Architectural Review Board Meeting Agenda
Monday, January 5, 2026, 4:00PM Norfolk
City Hall, 810 Union Street, 11th Floor

Subject: #25-00328 COA for after-the-fact
approval of porch and landscape bed
renovation

Subject: #25-00330 COA to rezone 520 W
22nd Street and 700 W 22nd Street into the
Norfolk & Western Railroad Historic District
and to renovate the building for residential
use

708 W Princess Anne – Demonstrating they have the same can lights as we have installed. Additionally, the decking and stair treads are the same composite materials that we utilized. The railings utilized the same materials as our railings.

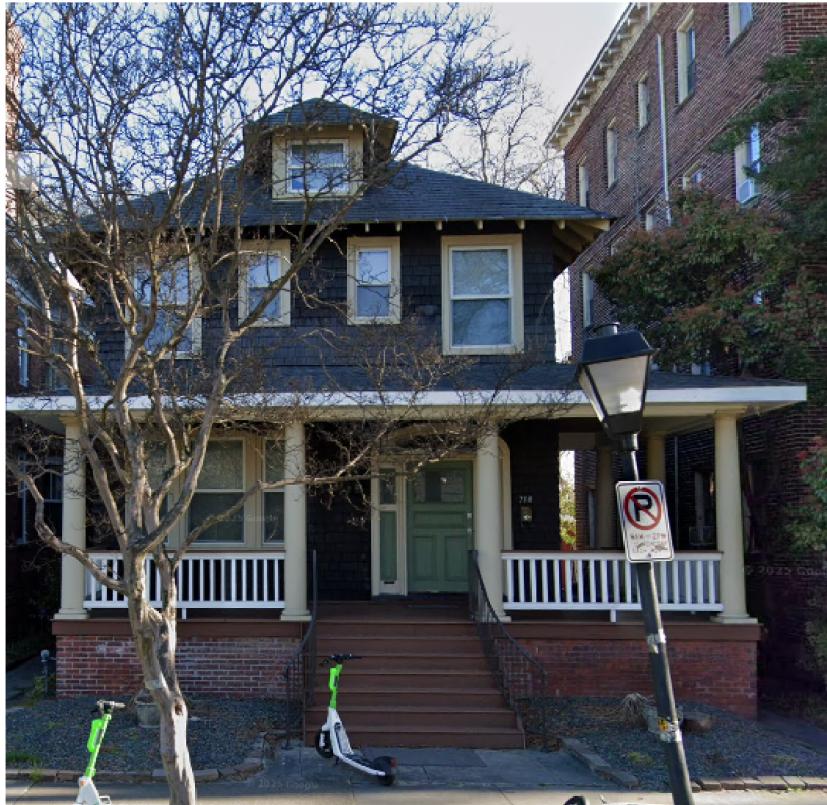
1. Replacement of historic, turned wood balusters with new composite, square balusters
2. Installation of composite top rail on porch railing
3. Installation of Chippendale-style screen on the east end of the front porch

Staff was unable to review the condition of the historic porch railing that was removed; however, the applicant has said the wood was rotting and insect damaged. Even assuming that all the wood features were beyond repair, the Historic District Design Guidelines recommend replacing features with in-kind designs when the historic material is beyond repair and to not introduce, recreate, or alter porch features that would create a false historical appearance. The turned balusters were a character-defining element of this building and many of the historic porches on the 700 block of W Princess Anne Road retain turned balusters. Reconstruction of the railing necessitated increasing the height to meet current building codes, however, there are measures that can meet the code height requirement while preserving the sense of the original proportions of the railing, such as use of a booster rail. Staff will note that the railings are largely obscured by mature, dense shrubs that have been planted in the front landscaping bed and that effectively screen the porch. Additionally, while the composite rail that was installed atop the Chippendale panels, it is visually distinct and helps identify the railing as a later alteration.

1. The Chippendale panels that partially enclose the east end of the porch shall be removed.
2. The Chippendale-style railing panels on the front porch shall be replaced with turned balusters similar in profile to the historic balusters.

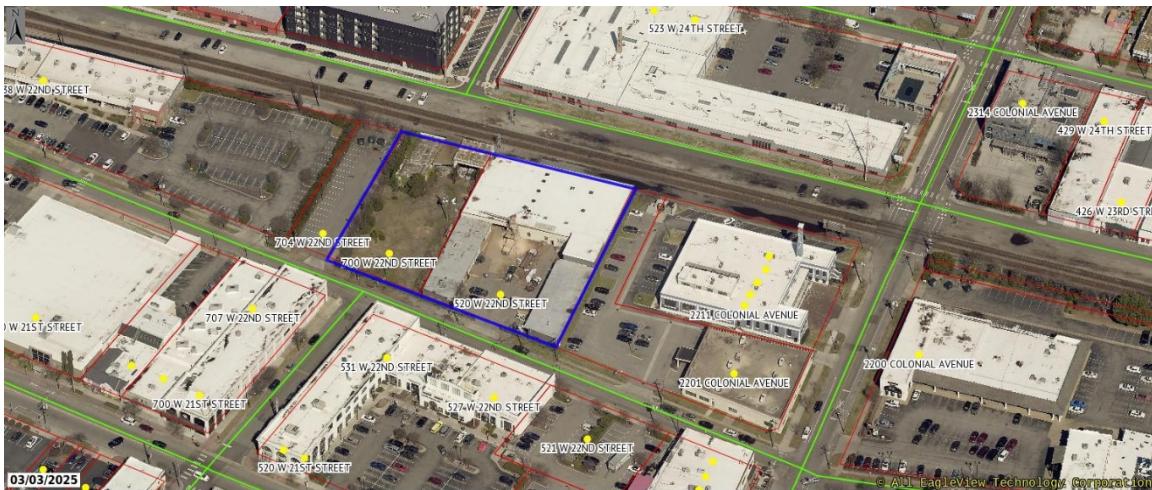
The applicant has stated they will retain the existing sawdust exhaust tower, rehabilitate it, and restore the painted signage. This work is consistent with the district's guidelines for signage. Staff notes that there is a painted sign on the east elevation of the west wing of the U plan that should also be retained.

1. The painted "YUKON" wall sign shall be retained.
